Product / Process Change Notification (PCN)

PCN Number:	PCN_IndHCIA_20250228	Change Category:
Affected Series:	WE-HCIA	<input type="checkbox"/> Equipment/Location
Affected Order Codes:	Please refer to table 1	<input checked="" type="checkbox"/> General Data
PCN Date:	2024-08-28 (YYYY-MM-DD)	<input type="checkbox"/> Material
Effective Date:	2025-02-28 (YYYY-MM-DD)	<input type="checkbox"/> Process
		<input type="checkbox"/> Product Design
		<input checked="" type="checkbox"/> Shipping/Packaging
		<input type="checkbox"/> Supplier
		<input type="checkbox"/> Software

Description of Change:
 Due to packaging optimizations, Würth Elektronik eiSos will change the product's packing method. Würth Elektronik eiSos will ensure some datasheet corrections for the product series WE-HCIA with sizes and order codes indicated in table 1.

Table 2. Packaging Changes of affected Order Codes

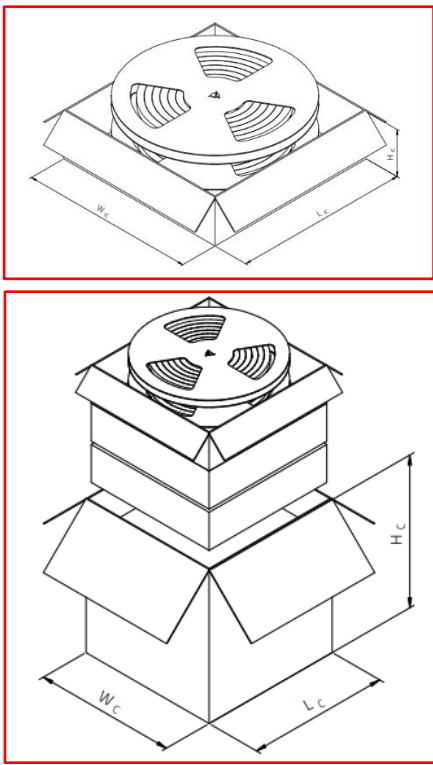
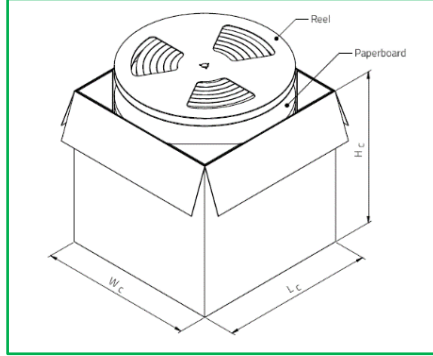
1. To reduce the amount of packaging waste in the product series WE-HCIA, with sizes and order codes indicated in table 1, the inner boxes will be omitted. No plastic filler will be used, and every reel will be stacked and separated by paperboard. The outer box dimension, reel quantity (pcs.), and box quantity (pcs.) will be updated accordingly. Additional details of the changes can be found in the table below:

L_c (mm)	360,00
W_c (mm)	360,00
H_c (mm)	370,00
Outer Box Qty.(pcs.)	4200

L_c (mm)	360,00
W_c (mm)	360,00
H_c (mm)	240,00
Outer Box Qty.(pcs.)	4200

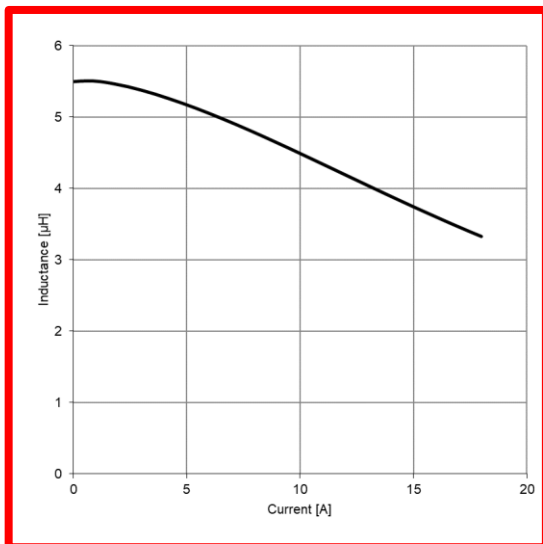
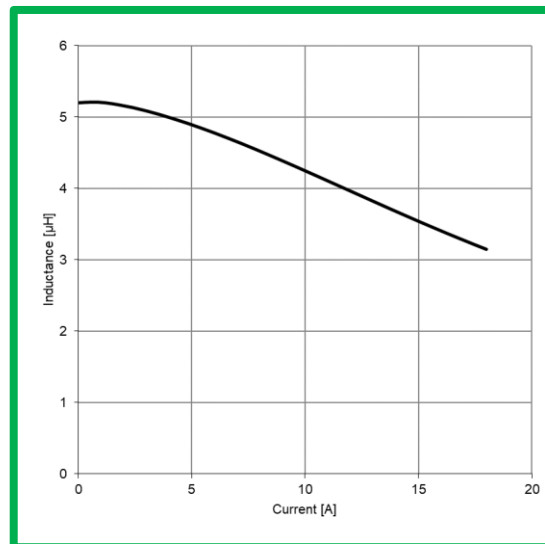
2. Due to a database mismatch, for the other code 784325055 "Typical Inductance vs. Current Characteristics" graph in datasheet will be corrected as follows:
